White Farm Equipment Company

Service Bulletin

Location Charles City
Subject Transmission –
1365-1370 Tractor
Number 430 740
Date 8-6-75
File C Transmission

Fig. 1.

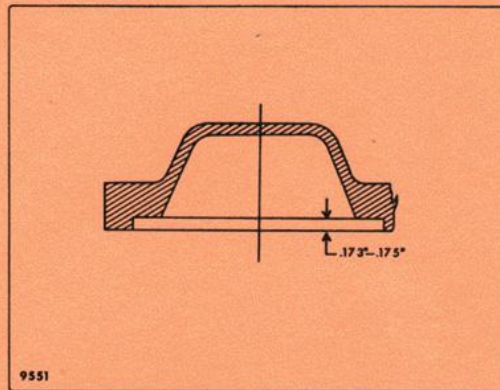
Transmission may jump out of 2nd and 4th gear on some 1365 and 1370 tractors.

670 228A Cover may be machined incorrectly. Cover should clamp lower shaft bearing and gasket simultaneously. As gasket is crushed lower shaft is forced to rear until snap ring contacts case preventing lateral movement of shaft. If 670 228A Cover has excessive counterbore, shaft is allowed to move forward with resulting gear disengagement.

If problem exists, remove 670 228A Cover and check cover as shown in Fig. 1. If counterbore exceeds .173-.175-inch in depth, purchase and install 670 228A Cover or mill existing cover to specification.
